PROPOSED RESIDENTIAL DEVELOPMENT

8330 SECTION 4.55 SUBMISSION 38 CUDGEGONG RD ROUSE HILL, NSW 2155

PROPOSED RESIDENTIAL DEVELOPMENT 38 CUDGEGONG RD ROUSE HILL, NSW 2155 L.G.A : BLACKTOWN CITY COUNCIL

SHEET TITLE: ELEVATIONS - BLOCK A

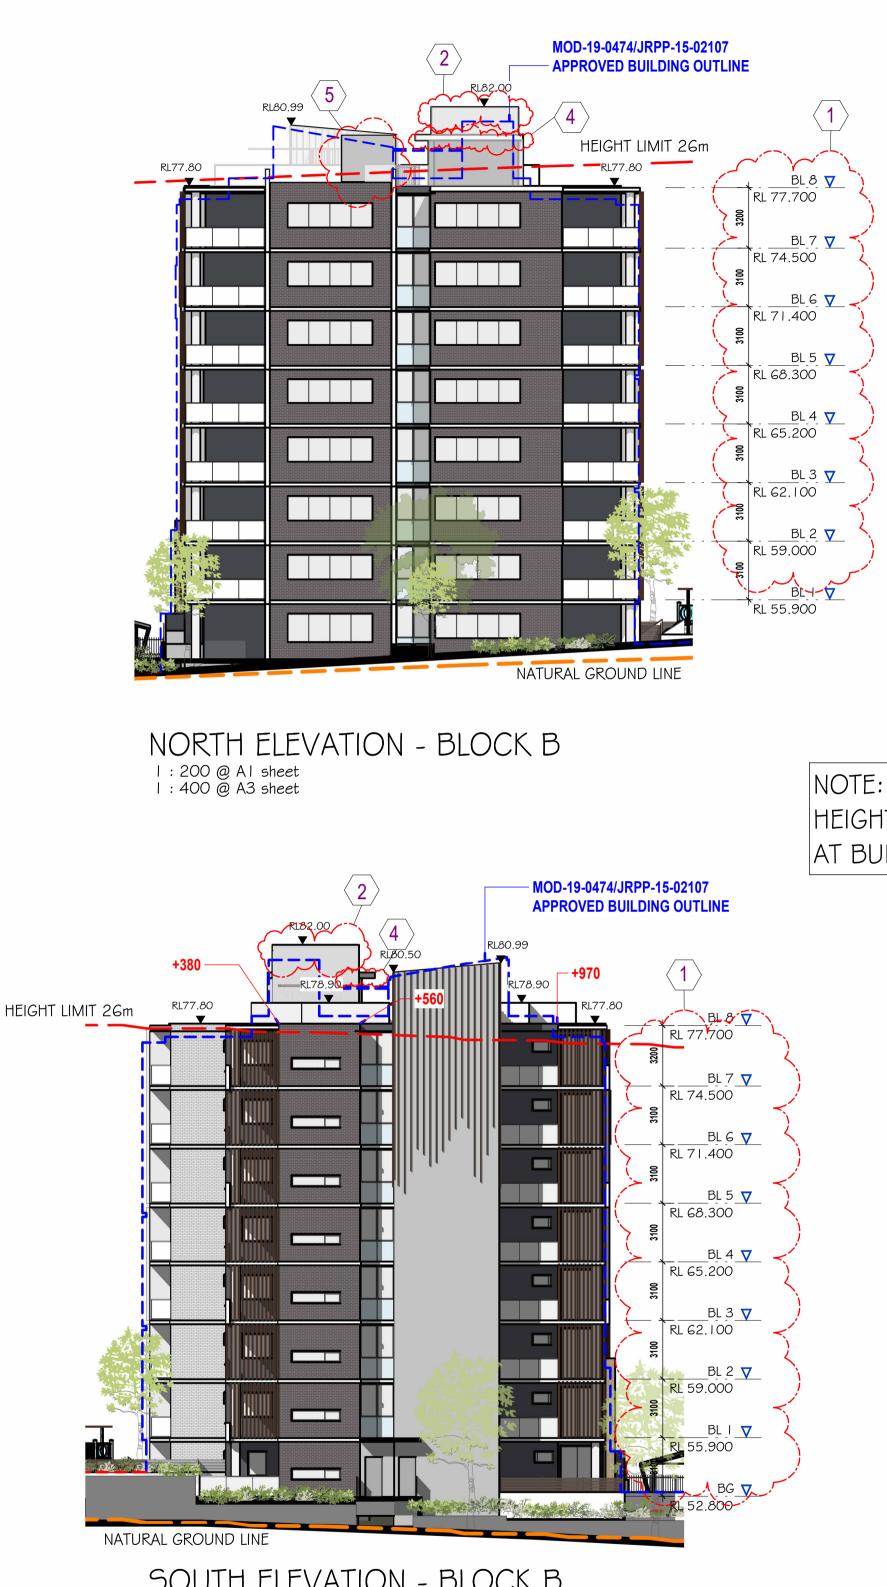
- I FLOOR TO FLOOR HEIGHTS ADJUSTED AS CLOUDED TO COMPLY WITH ADG REQUIREMENTS
- 2 SECOND LIFT ADDED TO ADG REQUIREMENTS AND SERVICE SHAFT CONTINUED AS CLOUDED
- 3 SECOND LIFT ADDED TO ADG REQUIREMENTS AS CLOUDED
- 4 HOT WATER UNIT SCREENS SHOWN TO MATCH PREVIOUSLY APPROVED PLANS AS CLOUDED
- 5 ROOF LOBBY HEIGHTS REDUCED AS CLOUDED
- 6 STAIRS EXTENDED TO ROOFS & FIRE EGRESS PATH FENCING INDICATED AS CLOUDED FOR BCA COMPLAINCE
- 7 GENERAL EXTERNAL ROUND COLUMNS ADDED TO BALCONY CORNERS

SHEET TITLE: ELEVATIONS - BLOCK B

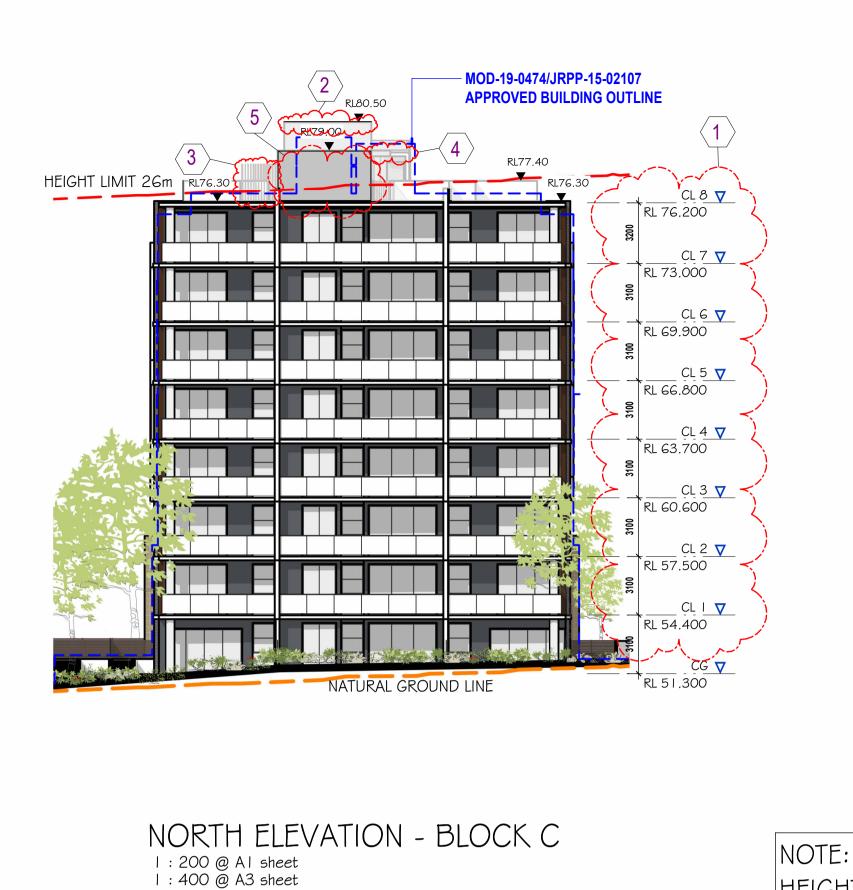
I - FLOOR TO FLOOR HEIGHTS ADJUSTED AS CLOUDED TO COMPLY WITH ADG REQUIREMENTS

- 2 SECOND LIFT ADDED TO ADG REQUIREMENTS AS CLOUDED
- 3 HOT WATER UNIT SCREENS SHOWN TO MATCH PREVIOUSLY APPROVED PLANS AS CLOUDED
- 4 ROOF LOBBY HEIGHTS REDUCED AS CLOUDED
- 5 STAIRS EXTENDED TO ROOFS & FIRE EGRESS PATH FENCING INDICATED AS CLOUDED FOR BCA COMPLAINCE
- 6 GENERAL EXTERNAL ROUND COLUMNS ADDED TO BALCONY CORNERS

ELEVATIONS - BLOCK C

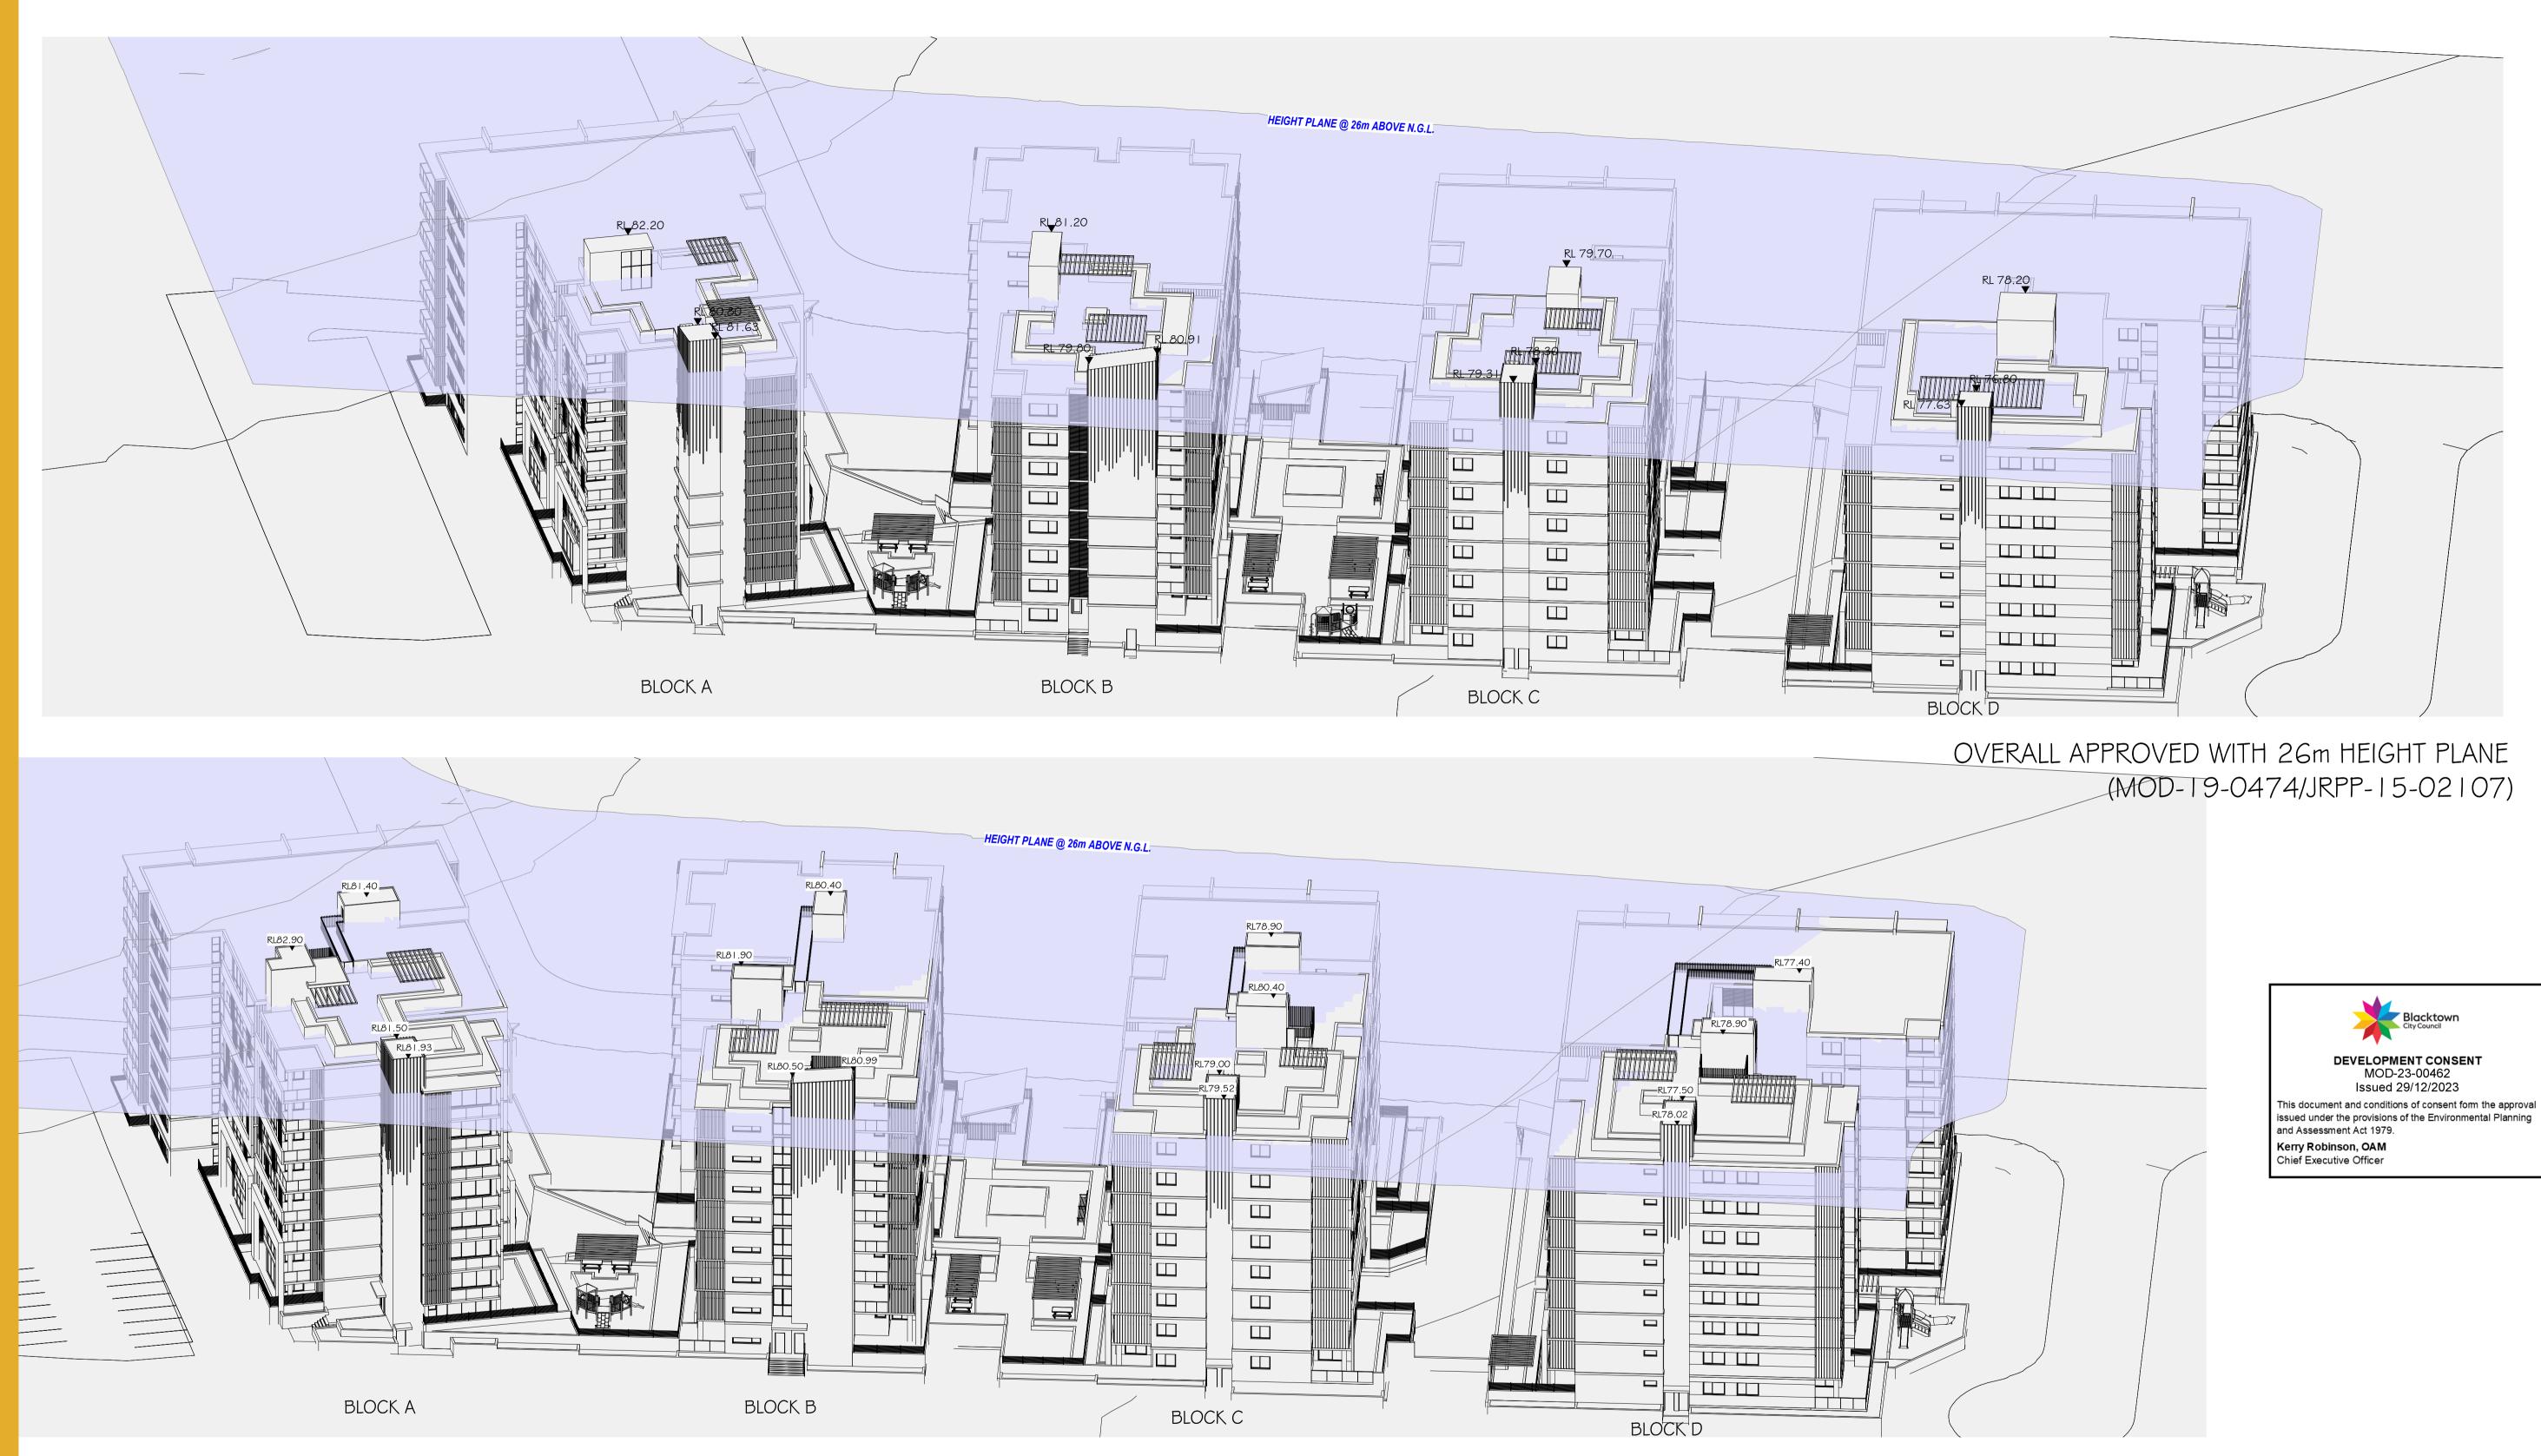
- I FLOOR TO FLOOR HEIGHTS ADJUSTED AS CLOUDED TO COMPLY WITH ADG REQUIREMENTS
- 2 SECOND LIFT ADDED TO ADG REQUIREMENTS AS CLOUDED
- 3 HOT WATER UNIT SCREENS SHOWN TO MATCH PREVIOUSLY APPROVED PLANS AS CLOUDED
- 4 ROOF LOBBY HEIGHTS REDUCED AS CLOUDED
- 5 STAIRS EXTENDED TO ROOFS ∉ FIRE EGRESS PATH FENCING INDICATED AS CLOUDED FOR BCA COMPLAINCE
- 6 GENERAL EXTERNAL ROUND COLUMNS ADDED TO BALCONY CORNERS

SHEET TITLE: SOLAR STUDIES 2

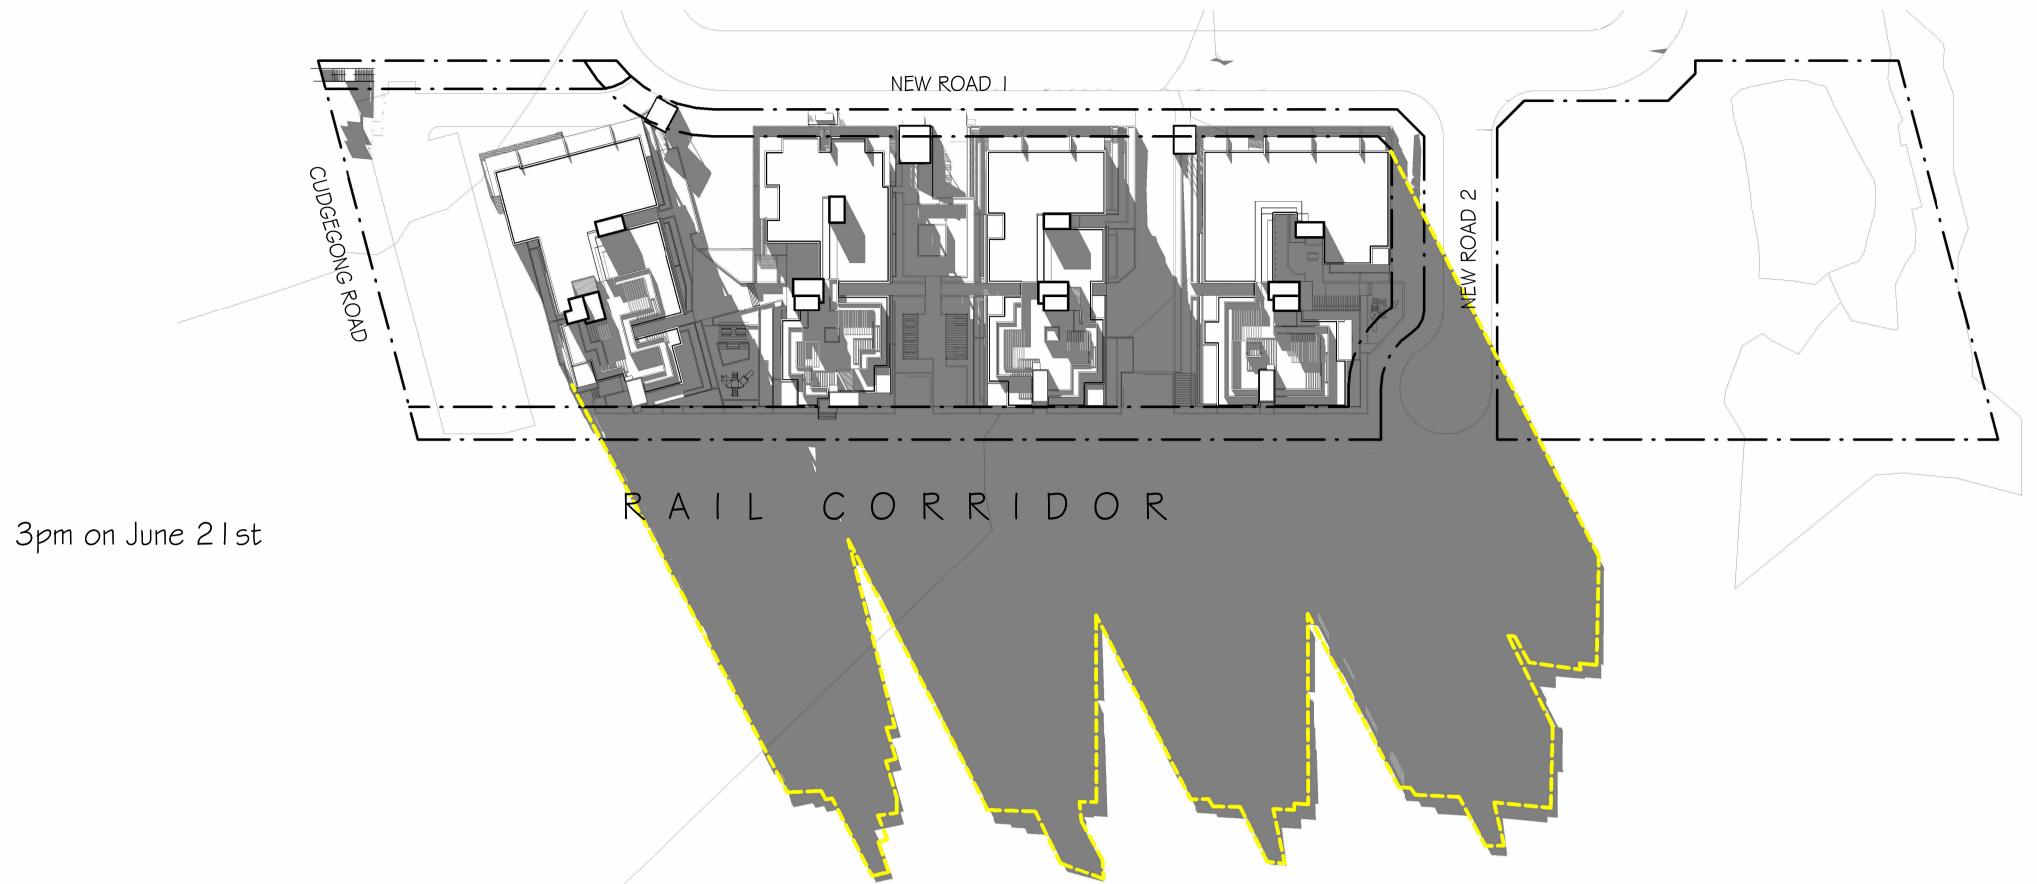
SUMMARY OF PROPOSED MODIFICATIONS: I - FLOOR TO FLOOR HEIGHTS REVISED 2 - STAIRS EXTENDED TO ROOFS AND FIRE EGRESS PATHS INDICATED
